ADDRESS : [REDACTED] SUBDIV: TINGEN POINTE PH6
CONTRACTOR : CATES BUILDING INC PHONE : (910) 481-0503
OWNER . . : THE HARNETT LAND GROUP II LLC PHONE :
PARCEL . . : 03-9576-01- -0088- -81-
APPL NUMBER: 14-50034278 CP NEW RESIDENTIAL (SFD)
DIRECTIONS : T/S: 07/25/2014 09:17 AM JBROCK ----
[REDACTED]

STRUCTURE: 000 000 42X45 3BDR MONO W/ GARAGE

VIOLATION NOTICE

Re: J0814-3832

Job JD814-3832	Truss F04	Truss Type FLOOR TRUSS	Qty 5	Ply 1	Lot 169 Tingen Pointe _ Harnett Co. 7.430 s Jul 25 2013 MiTek Industries, Inc. Tue Nov 18 10:20:03 2014 Page 1	EB470485
-------------------	--------------	---------------------------	----------	----------	---	----------

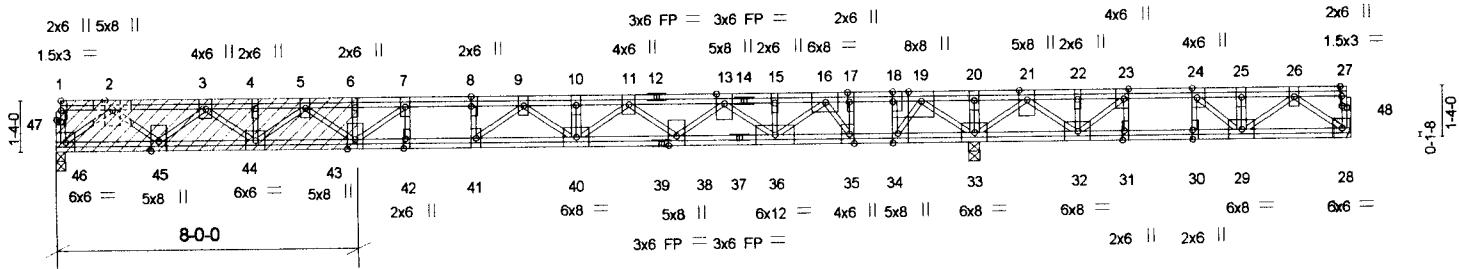
12" SECTION OF TRUSS REMOVED

ATTACH 2 LAYERS 3/4" PLYWOOD OR OSB GUSSET (23/32" APA RATED SHEATHING 48/24 EXP 1) TO ONE SIDE OF TRUSS WITH CONSTRUCTION QUALITY ADHESIVE AND ONE ROW OF #12 (.216" DIA.) X 3" WOOD SCREWS 3" O.C. IN ALL MEMBERS. GLUE PLYWOOD LAYERS TOGETHER PRIOR TO ATTACHING TO TRUSS. A 1/8" DIA. PILOT HOLE SHALL BE DRILLED FOR EACH WOOD SCREW. DO NOT USE DRYWALL OR DECKING TYPE SCREWS.
